ADDENDUM NO. 2

**Accessibility Improvements, Multiple Group Camp Assets
Crowder State Park
Trenton, Missouri
PROJECT No.: X2534-01**

ADDENDUM #2

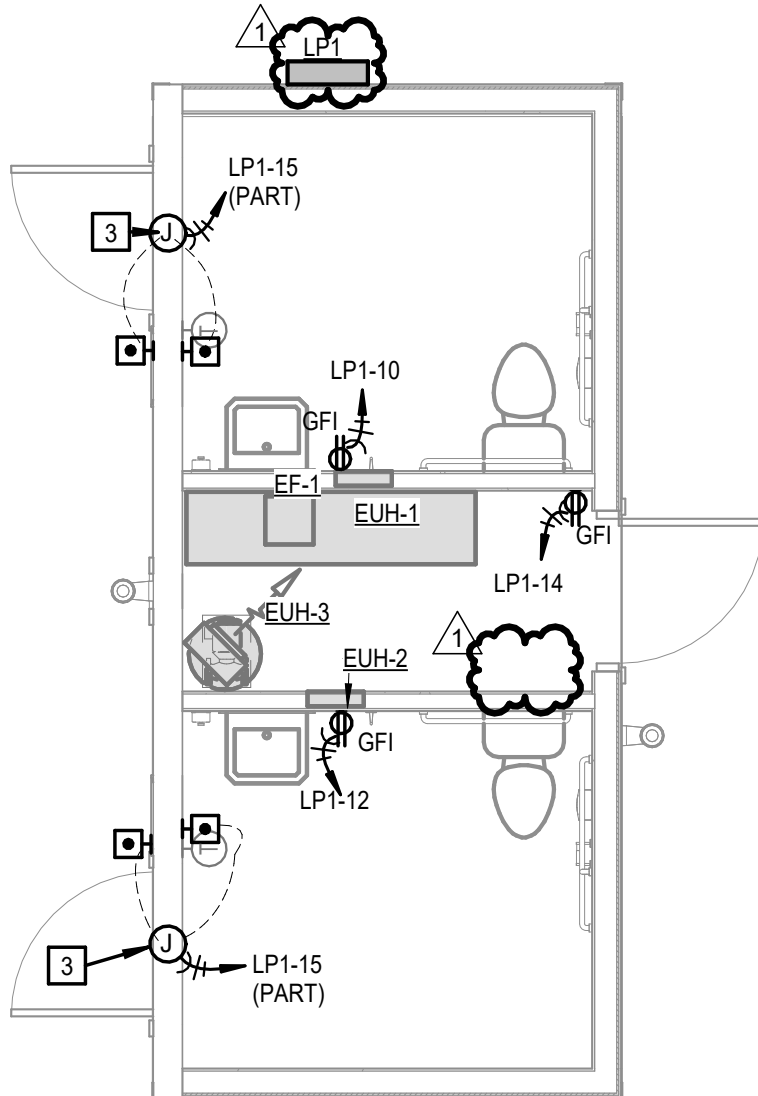
6. SHEET M-1 (ALT-2) - RECREATION BUILDING HVAC AND PLUMBING PLAN
 - a. REVISE Note 1. See attached drawing A2-3.
7. SHEET E-2 - RESTROOM ELECTRICAL PLANS

- ① CONNECT EXISTING LP THREADED STEEL PIPE GAS LINE TO AHU-1.
- ② REUSE AND CONNECT NEW AHU-1 TO EXISTING FLUE.
- ③ ROUTE THROUGH TRUSS SPACE.

1 POWER PLAN - RESTROOM BUILDING
1/4" = 1'-0"

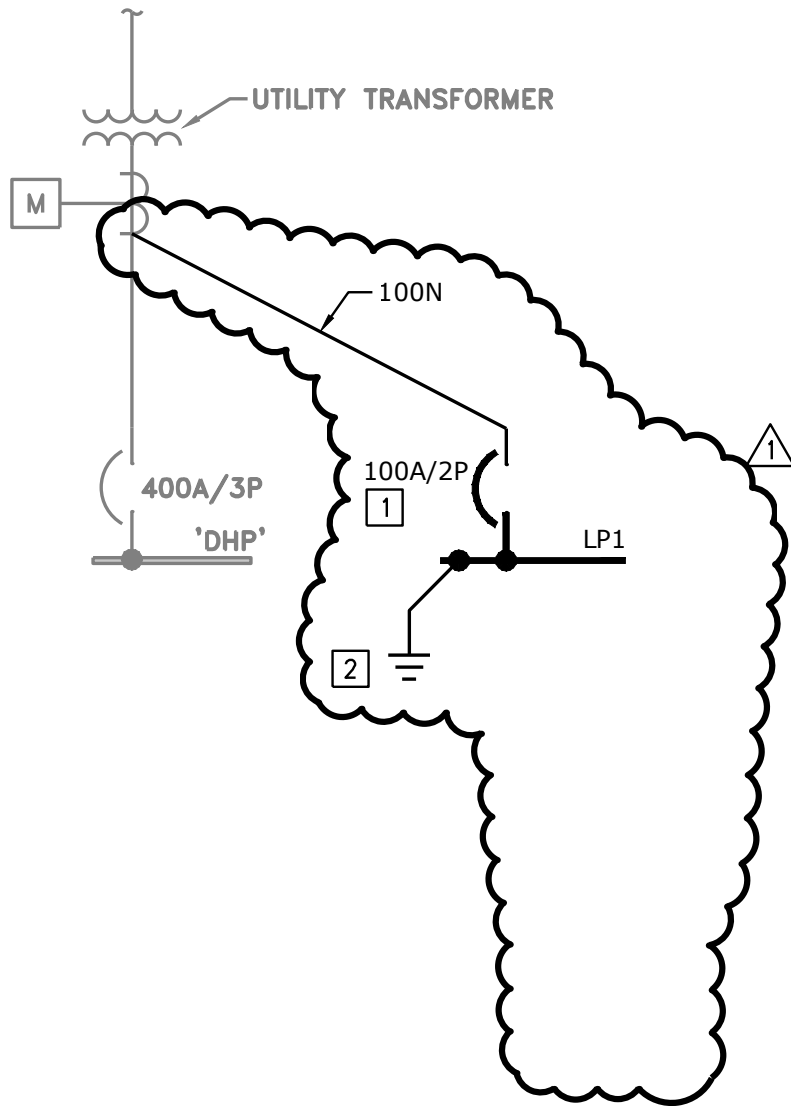
- a. REVISE to relocate panel LP1 to exterior of restroom building. See attached drawing A2-4.
8. SHEET E-3 - ELECTRICAL ONE LINE DIAGRAM
 - a. REVISE electrical service to Restroom Building. See attached drawing A2.5.

- 1 ROUTE CIRCUIT THROUGH ROOF MOUNTED PHOTOCELL.
- 2 PROVIDE WEATHERPROOF PHOTOCELL MOUNTED ON ROOF FACING NORTH.
- 3 PROVIDE POWER FOR ADA DOOR OPERATOR. MAKE ALL CONNECTIONS TO PUSH BUTTON AS REQUIRED. COORDINATE EXACT LOCATION WITH ARCHITECTURAL AND EXACT REQUIREMENTS WITH EQUIPMENT PROVIDED.

A2-6

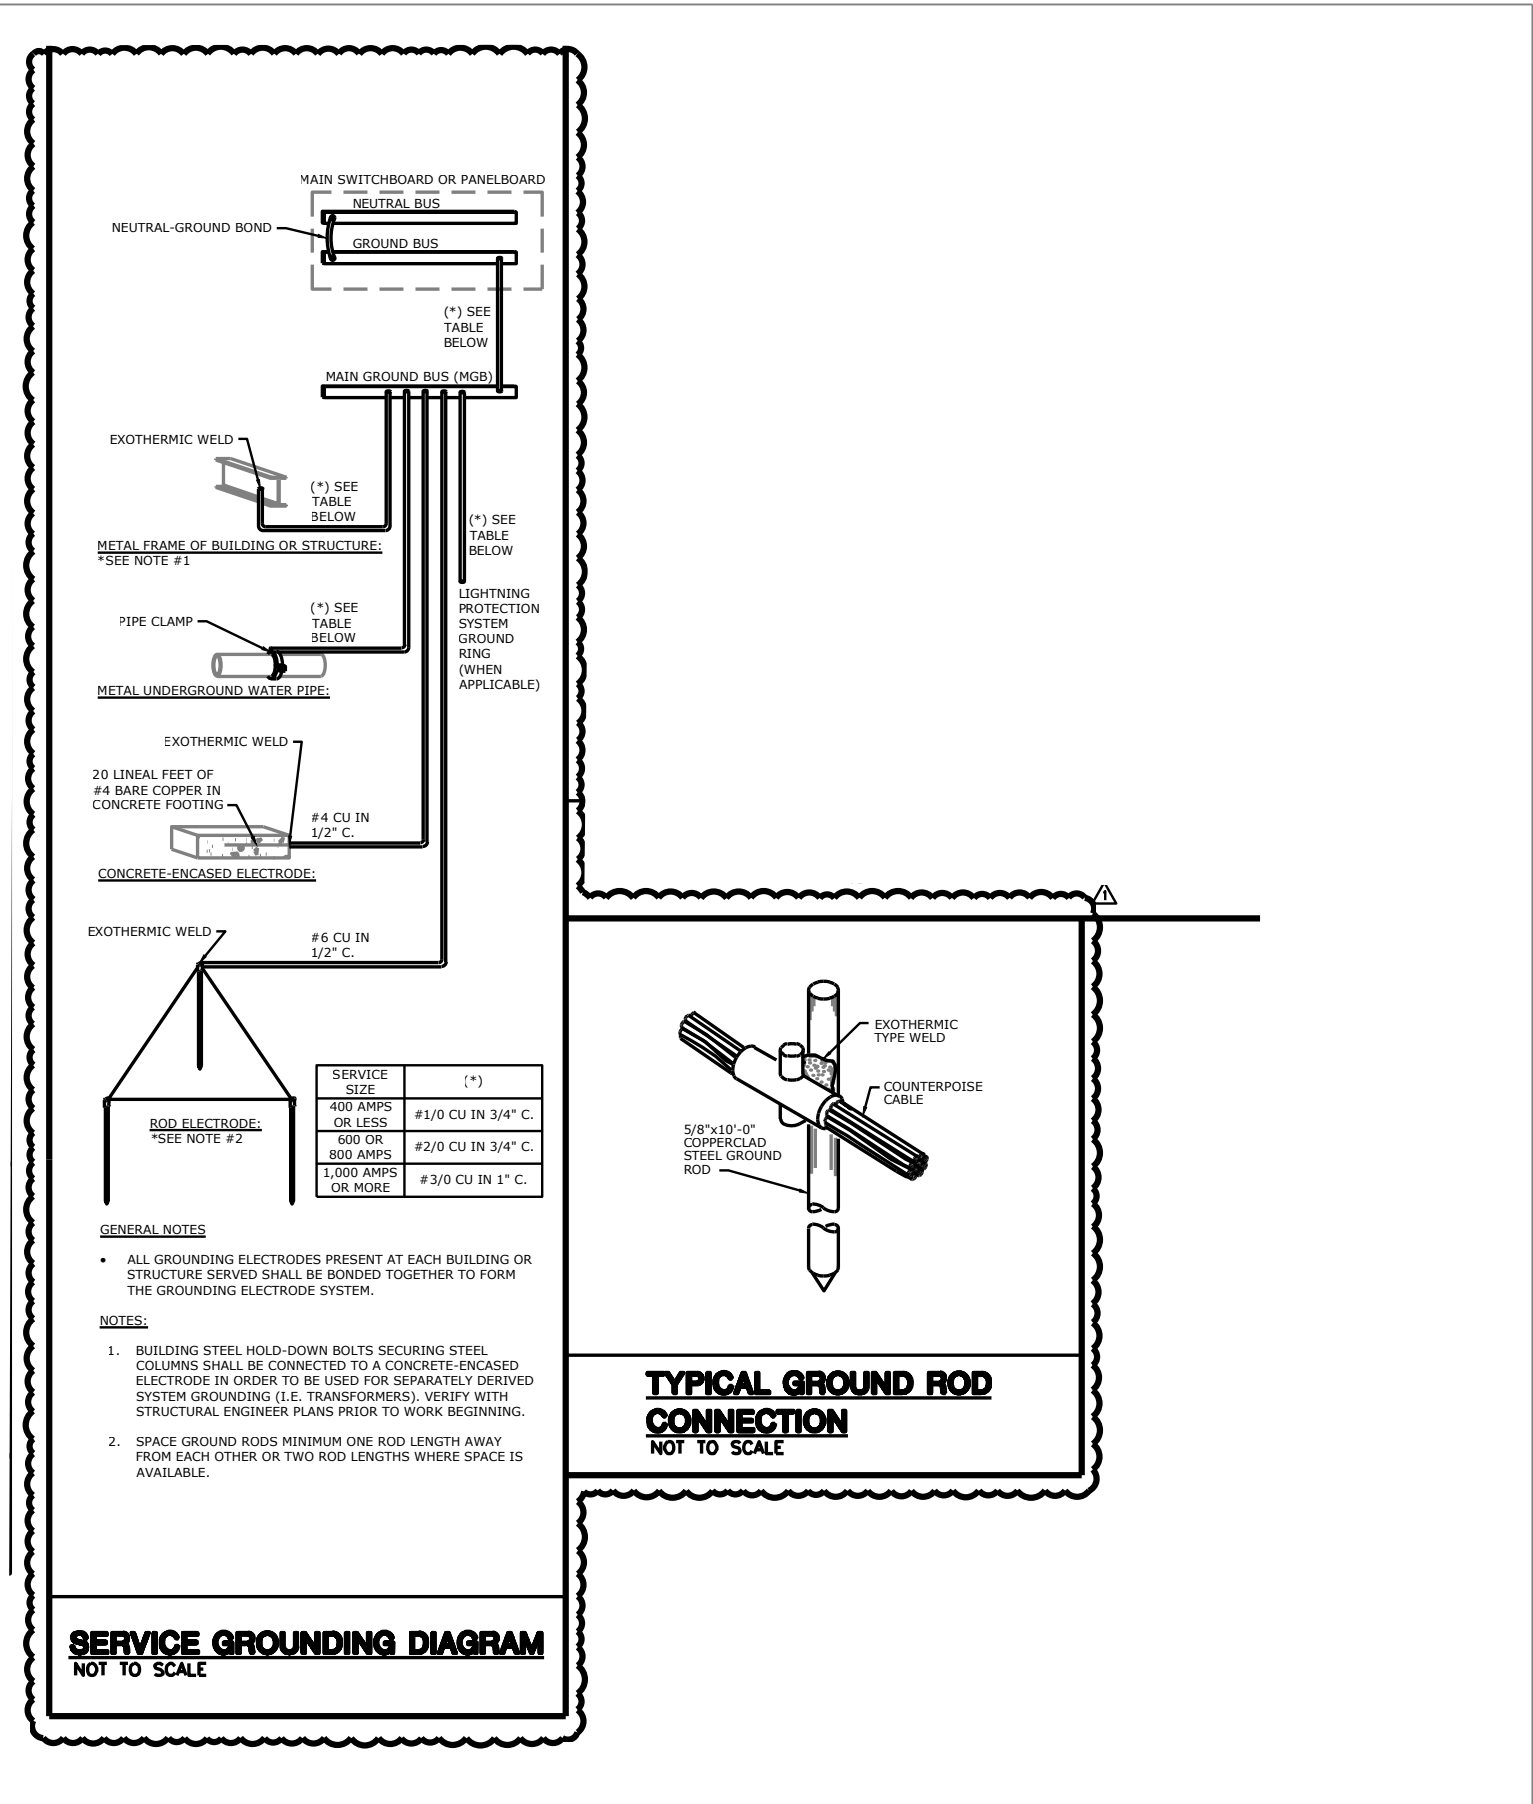
- b. ADD service grounding details. See attached drawing A2-6.
9. SHEET E-4 - ELECTRICAL SCHEDULES AND DETAILS
 - a. REVISE Nema enclosure of panel LP1 to 3R for exterior mounting. See attached drawing A2-7.

REFER TO SERVICE GROUNDING DETAIL.
